Re: **C and D Land Corp (Phase I)**  
**411 Wyoming SE**  
**Traffic Circulation Layout**  
**Engineer's Stamp 11-12-2020 (L19-D023)**

The TCL submittal received 11-12-2020 is approved for Building Permit with. A copy of the stamped and signed plan will be needed for each of the building permit plans. Please keep the original to be used for certification of the site for final C.O. for Transportation.

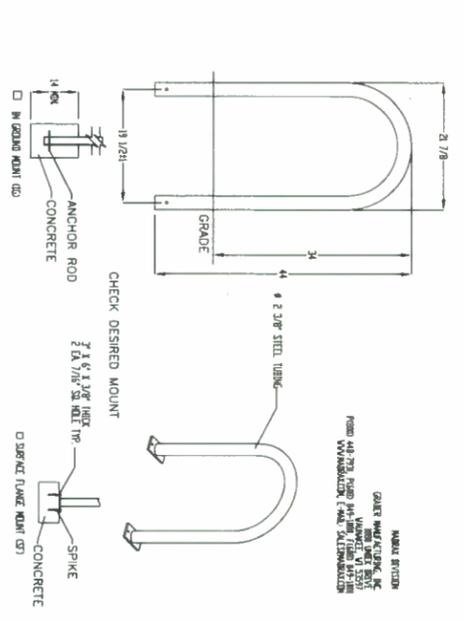
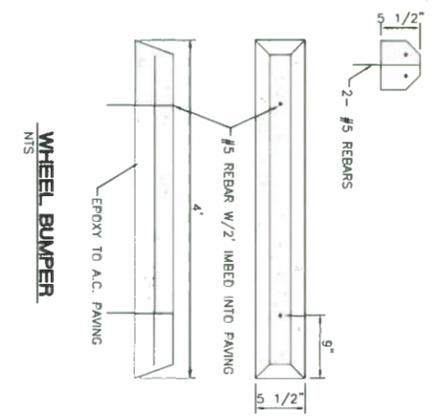
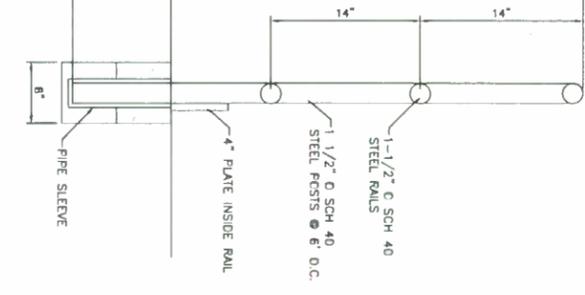
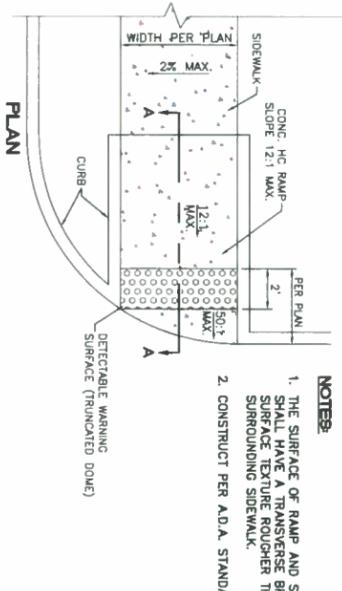
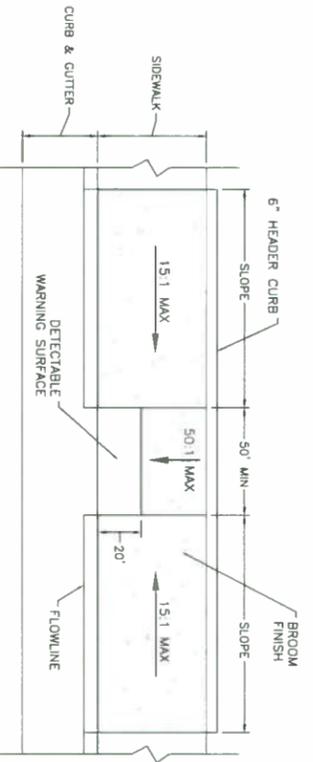
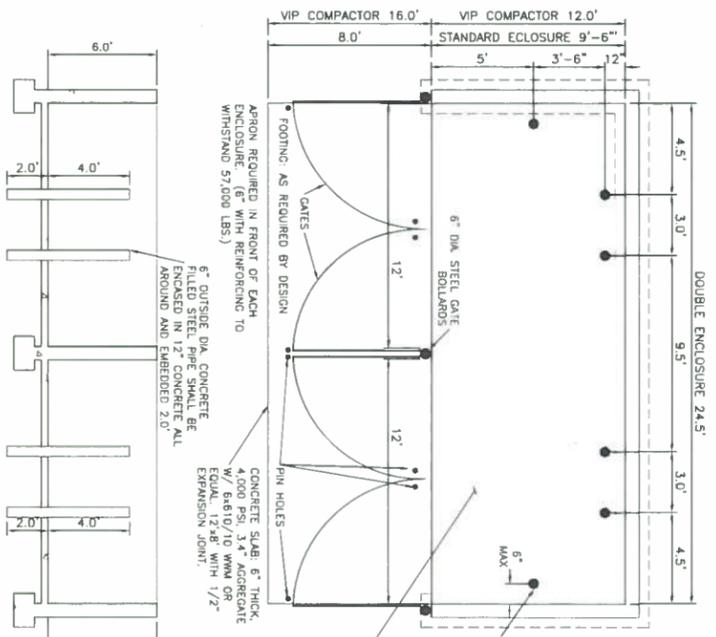
ALL WHEELCHAIR RAMPS LOCATED WITHIN THE PUBLIC RIGHT OF WAY MUST HAVE TRUNCATED DOMES.
